**Proposed Temporary Warehouse (Excluding Dangerous Goods Godown) with Ancillary Facilities
and Associated Filling of Land for a Period of 3 Years
in "Green Belt" Zone, Lots 1363 RP (Part) and 1364 (Part) in D.D.125
and Adjoining Government Land, Ha Tsuen, Yuen Long, New Territories**

Responses-to-Comments

(Application No. A/YL-HTF/1211)

LANDSCAPE PROPOSAL

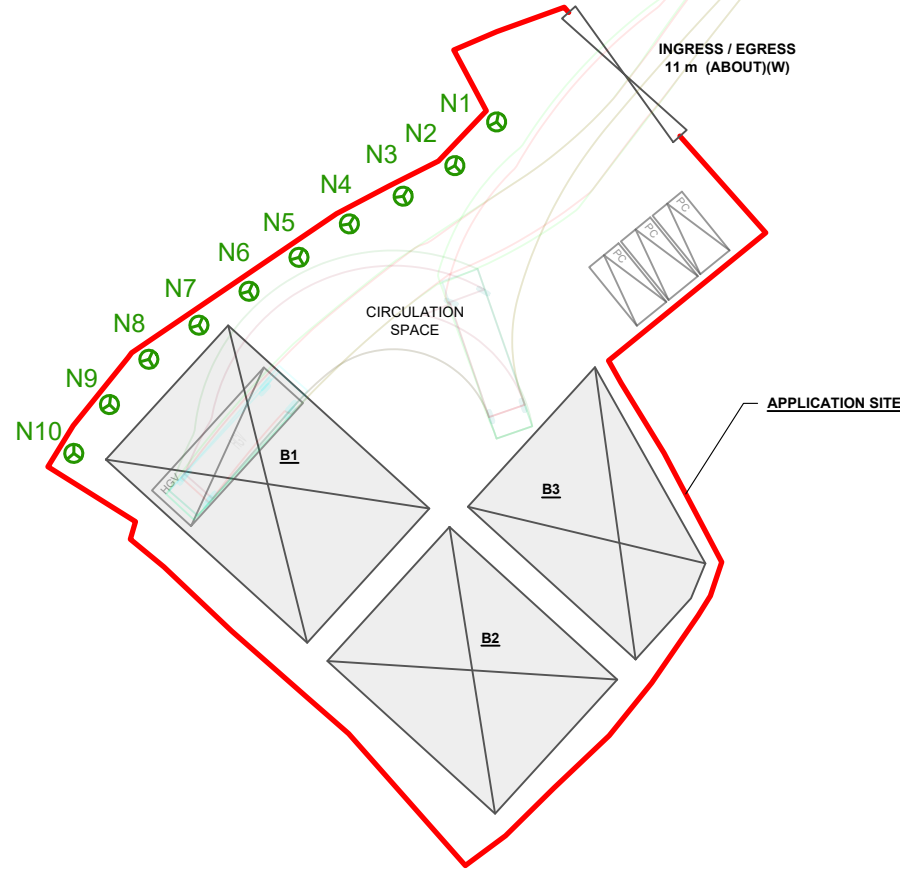
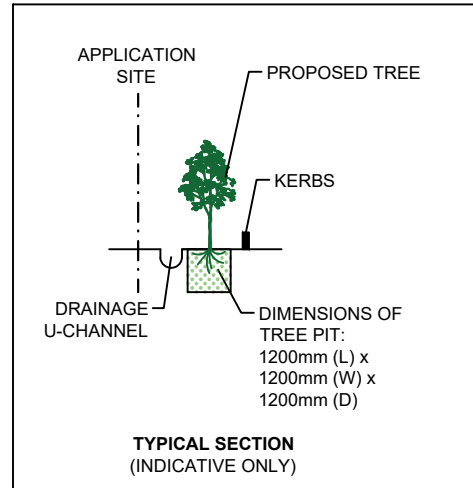
(a)	<p>We have reservation on the application from landscape planning perspective. The Site is zoned "Green Belt" on the approved Ha Tsuen Fringe Outline Zoning Plan No. S/YL-HTF/12. It is considered that the proposed use would alter or further affect the landscape character of a green belt. Moreover, no Landscape Proposal is provided to mitigate the landscape impact of the proposed use.</p>	<p>A landscape proposal is submitted by the applicant to provide landscape mitigation measures for the proposed development (Annex II). A total of <u>10</u> new trees are proposed to be planted along the northwest periphery of the application site (the Site) as a landscape buffer to minimise adverse visual impacts to the surrounding areas. All these new trees within the Site will be well-maintained by the applicant during the planning approval period.</p>
